Subject: 10CFR21 Reporting of Defects and Non-Compliance -  
Engine Systems, Inc. Report No. 10CFR21-0081

Refurbished Woodward EGB governor/actuators

**Report No. 10CFR21-0081**  
Rev. 0: March 6, 2001

## 10CFR21 REPORTING OF DEFECTS AND NON-COMPLIANCE

EXHIBIT 1

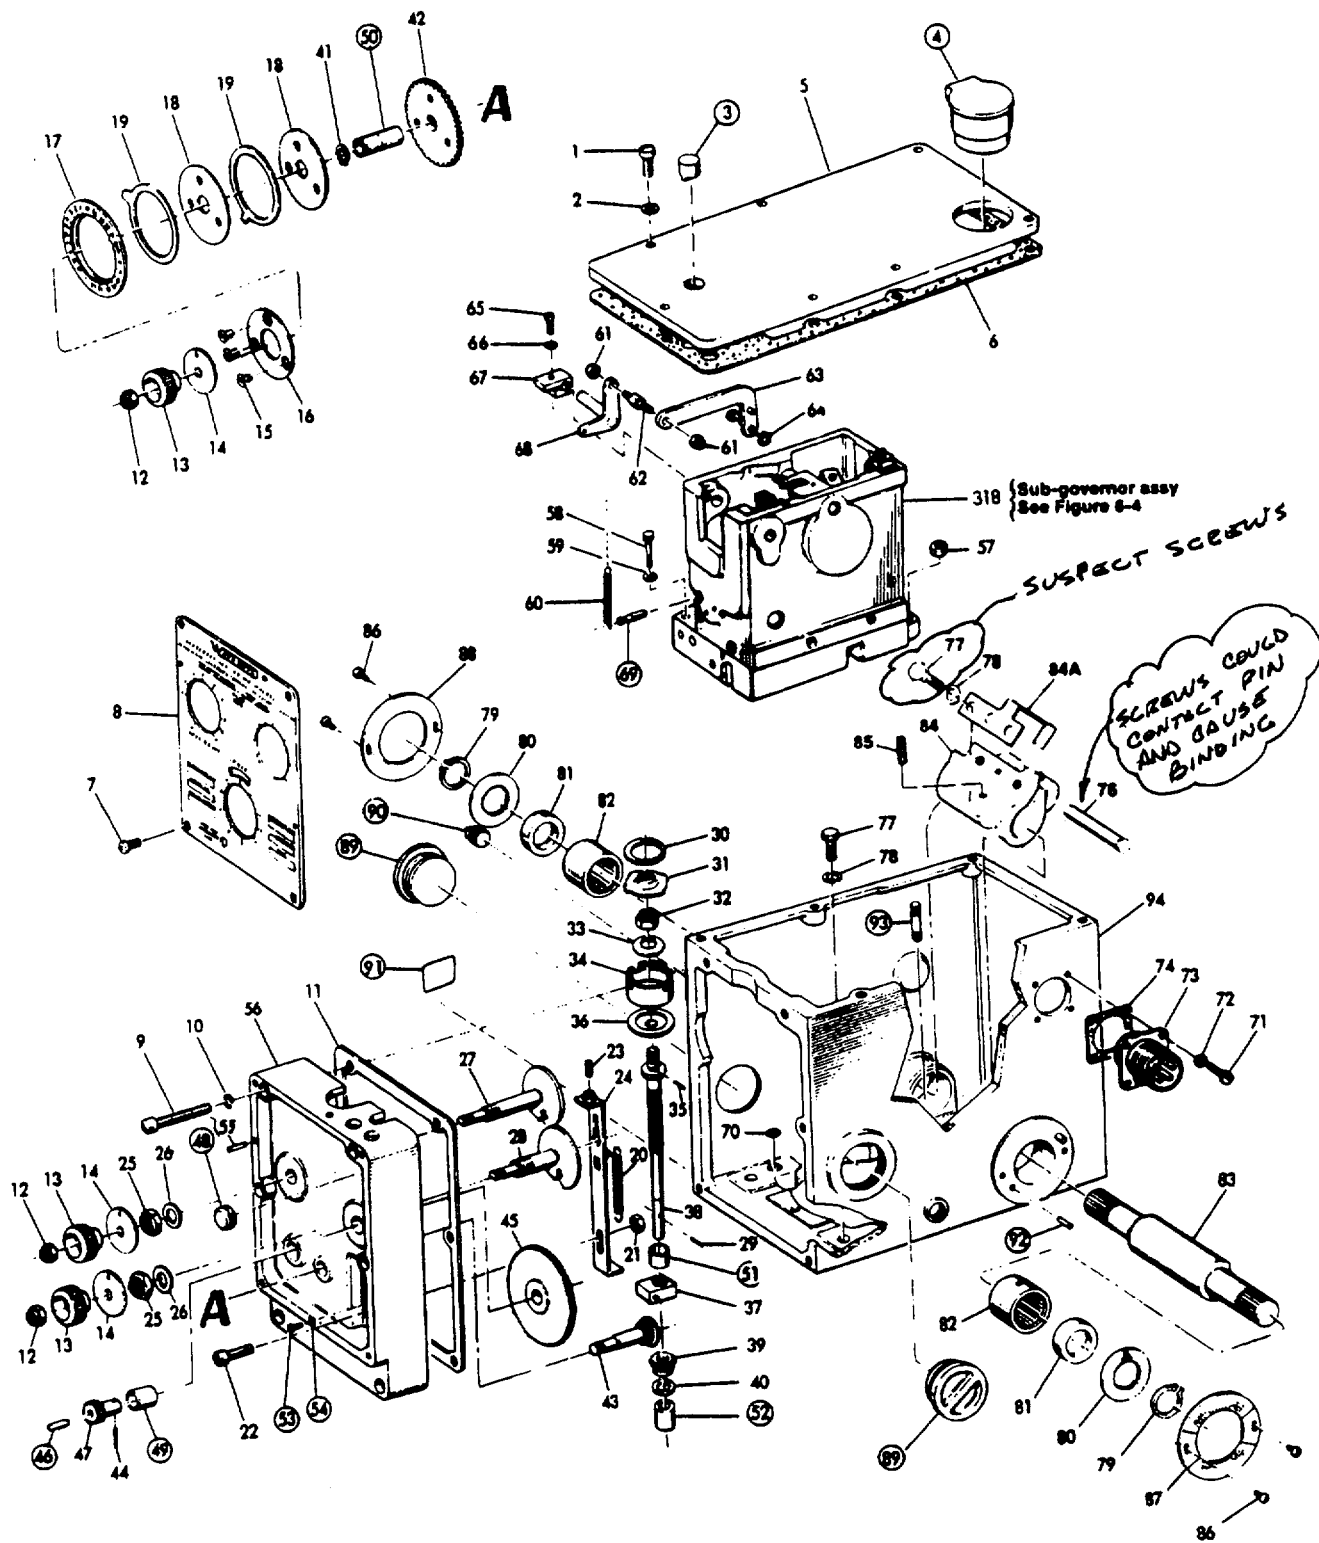
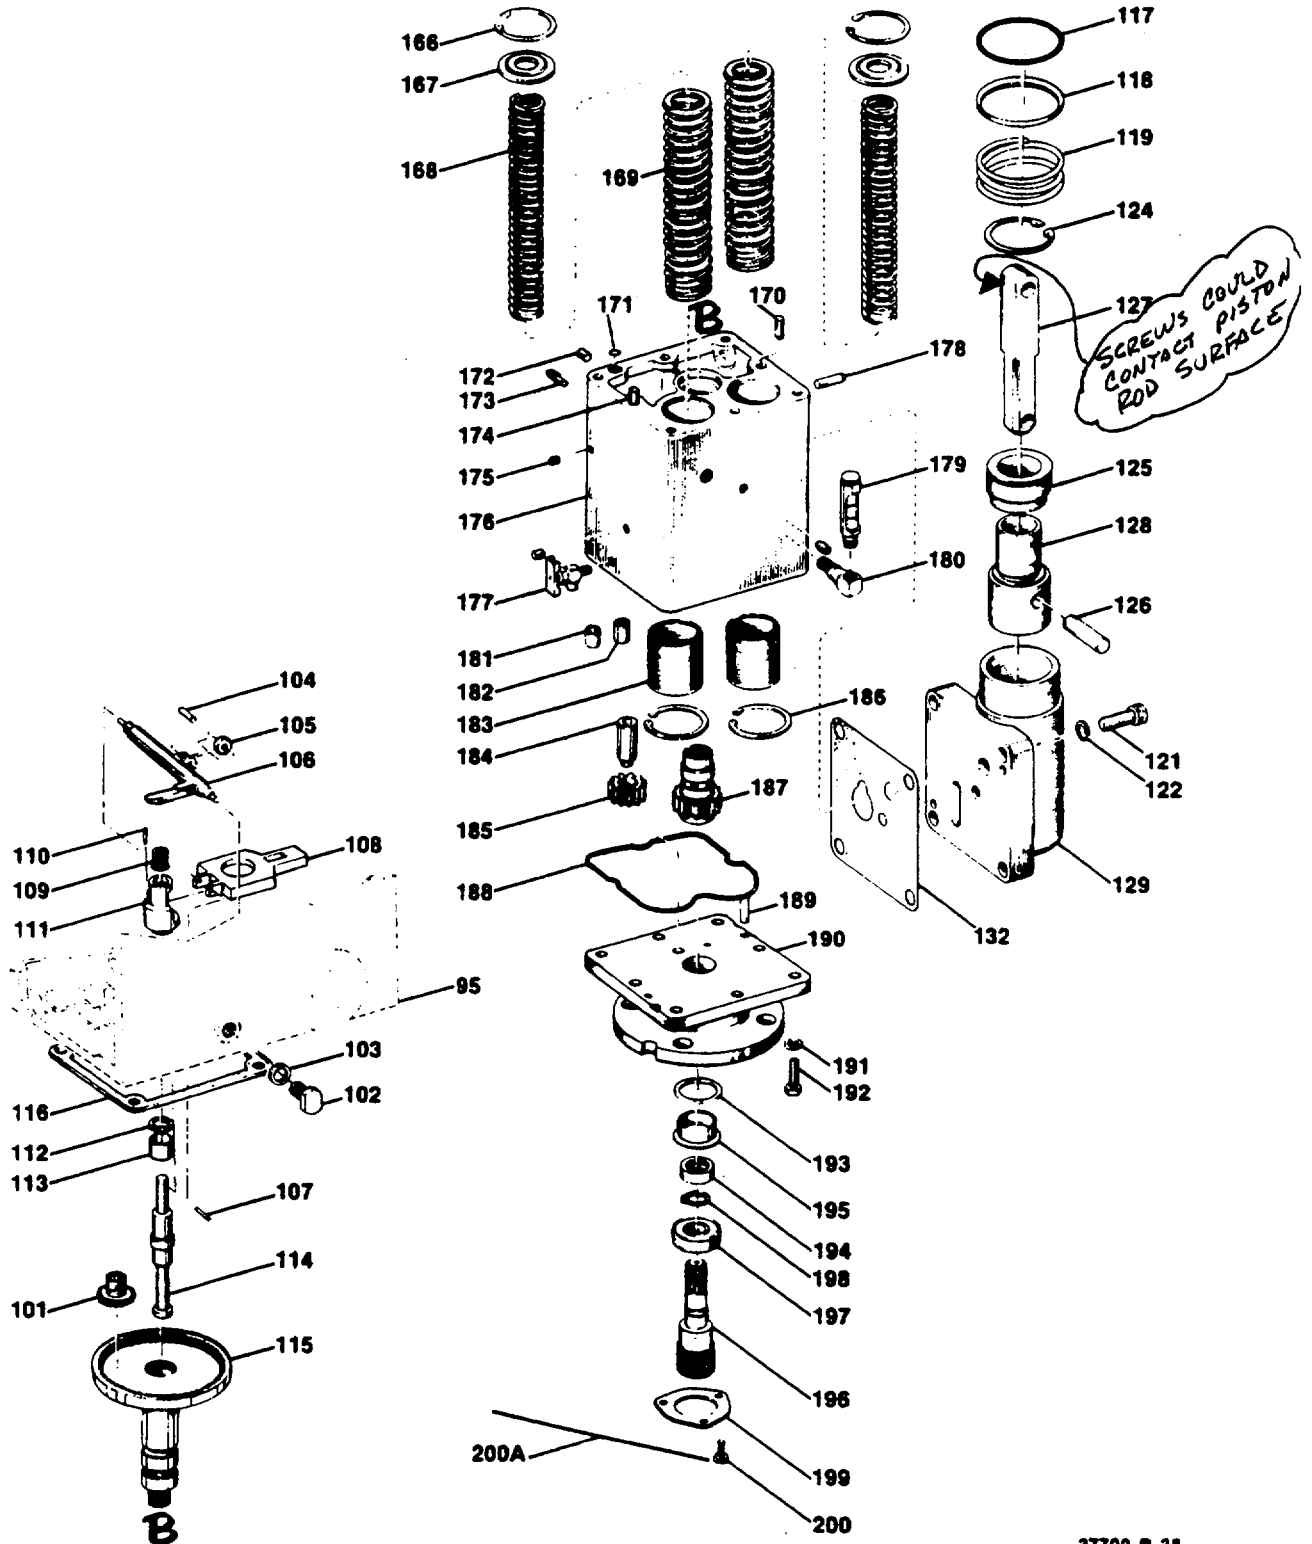
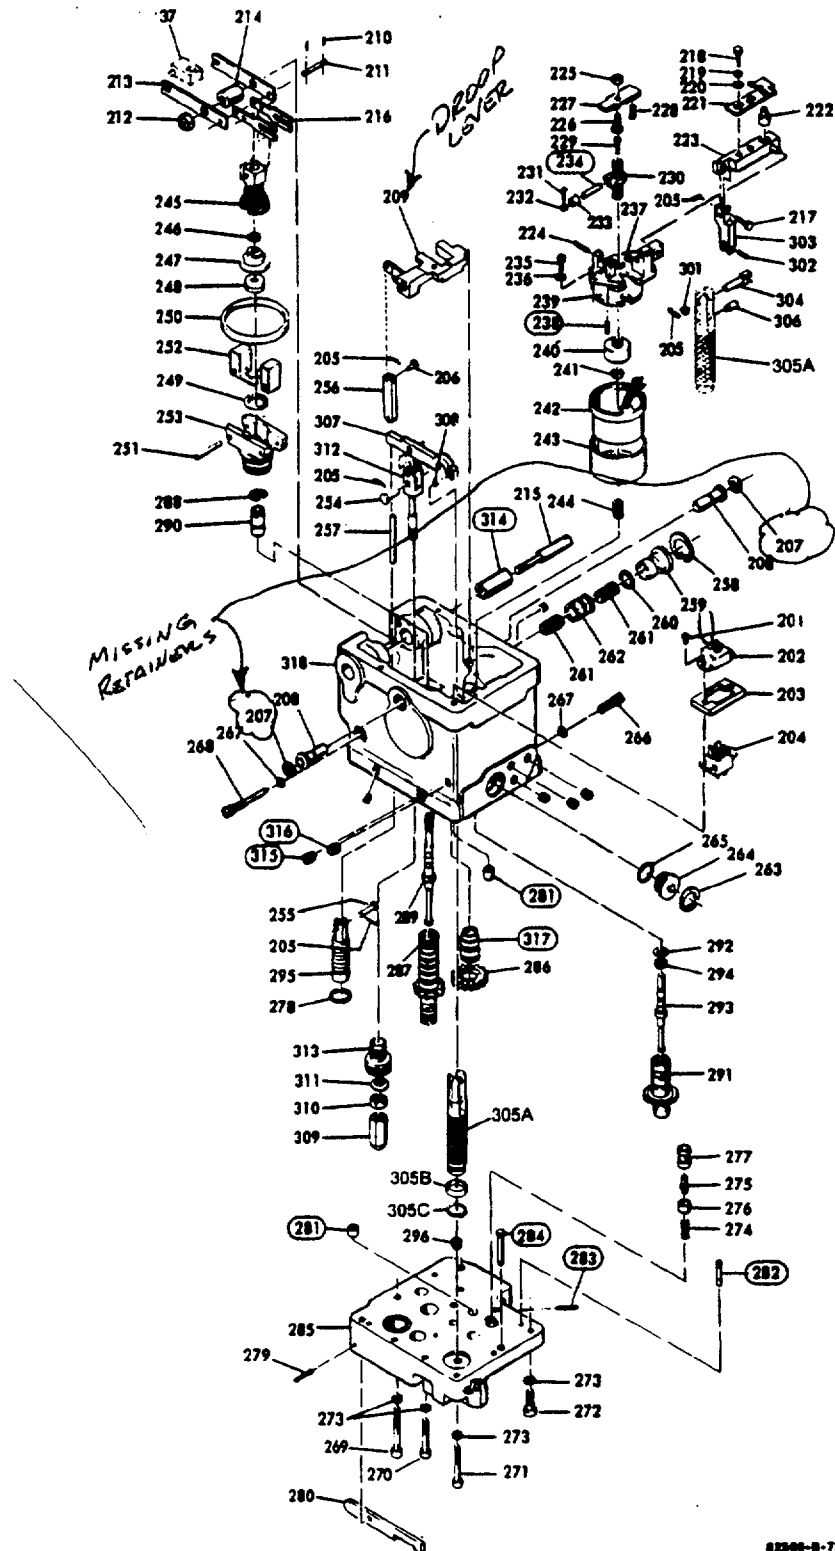
Engine Systems Inc. (ESI) has received notification about a potential problem with some refurbished Woodward EGB governor actuators. One problem was recently reported by V.C. Summer Nuclear Station, via Power Reactor Event Number 37788. Apparently, a governor experienced binding of the terminal shaft due to incorrectly applied clamping screws. ESI was not notified about this occurrence until after the Event Report was issue; therefore, ESI was not able to verify/evaluate the actual components involved. Another problem was also reported by J.A. Fitzpatrick Nuclear Plant with this governor. Operability problems were observed and an investigation revealed that the droop lever pivot pin retaining rings were omitted during reassembly of the governor. Due to the missing retaining rings, the pins eventually backed out, releasing the droop lever. This caused the mechanical speed setting to drop and interfere with electric governor operation (limited load carrying capability). A parts breakdown for the EGB is provided in Exhibit 1 with the above parts annotated.

ESI recommends returning the suspect governors to ESI for a completed tear-down inspection. ESI will reassemble and functionally test to Woodward specifications. NOTE: Even though the V.C Summer governor screw length issue was corrected, we still recommend a complete tear-down to verify all refurbishment activity is within specifications. The Fitzpatrick unit (s/n 2185499) was recently returned to ESI to replace the missing terminal shaft retaining rings. A complete tear-down inspection was performed at that time; no further action on this governor is required. Contact ESI's Customer Service Department for return instructions.
